## Service Information Bulletin

SUBJECT	DATE
SPN 411 (MCM) (GHG17)	August 2017

## 2 SPN 411/FMI 4 - GHG17

EGR Delta Pressure Sensor Circuit Failed Low

d540120

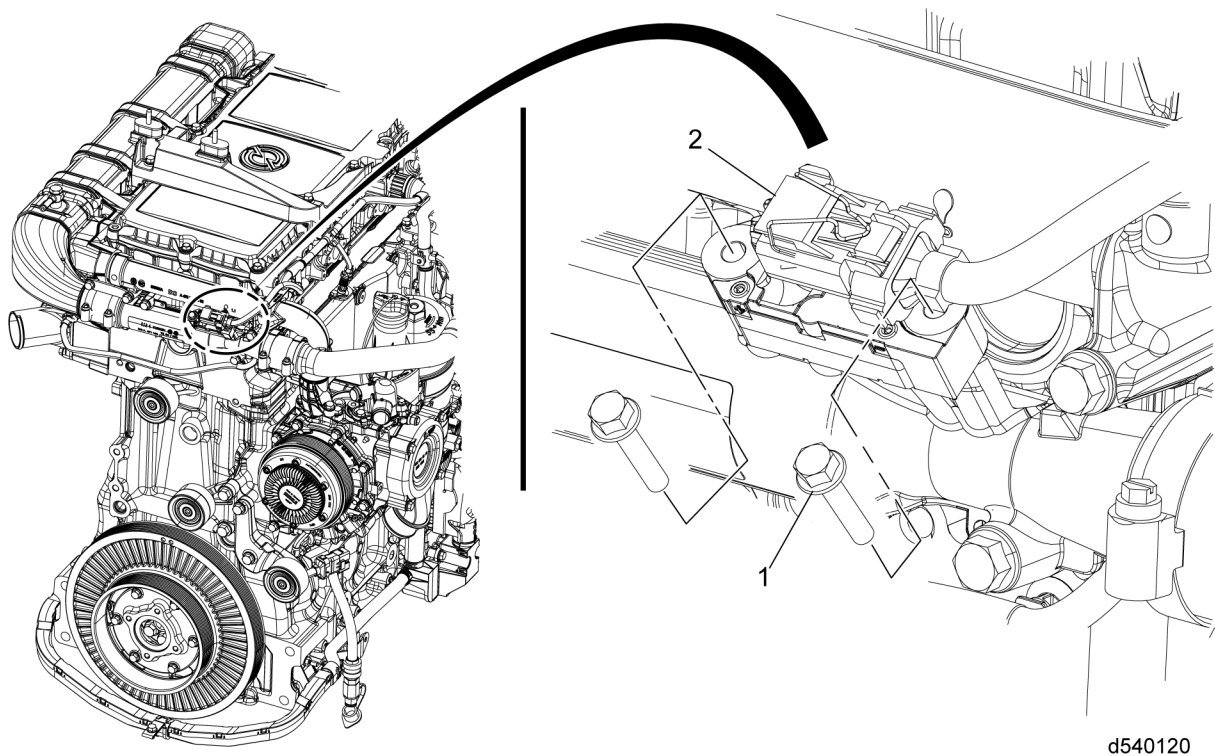
Publication Number / Title	Platform	Section Title	Change
DDC-SVC-MAN-0191	GHG17 HD DD	SPN 411/FMI 4 - GHG17	The diagnostic procedure has been updated. Removed the need to disconnect the MCM 120-pin electrical connector. Added step to jump pins. Added graphic to point out location of the sensor.

5. Disconnect and inspect the EGR Delta P sensor electrical connector harness side. Is there any corrosion present?
  - a. Yes; replace the EGR Delta P sensor and the electrical connector. Refer to section "Removal of the Delta P Sensor". Verify repair.

8. Turn the ignition ON (key ON, engine OFF).
9. Measure the voltage between pin 1 and pin 2 of the EGR Delta P sensor electrical connector harness side. Is the voltage between 4.5 and 5.5 volts?

- b. No; repair the circuit between pin 2 of the EGR Delta P sensor electrical connector harness side and the splice. Verify repair.
11. Use the appropriate flex probes to jump pin 1 and pin 3 of the EGR Delta P sensor electrical connector harness side together.
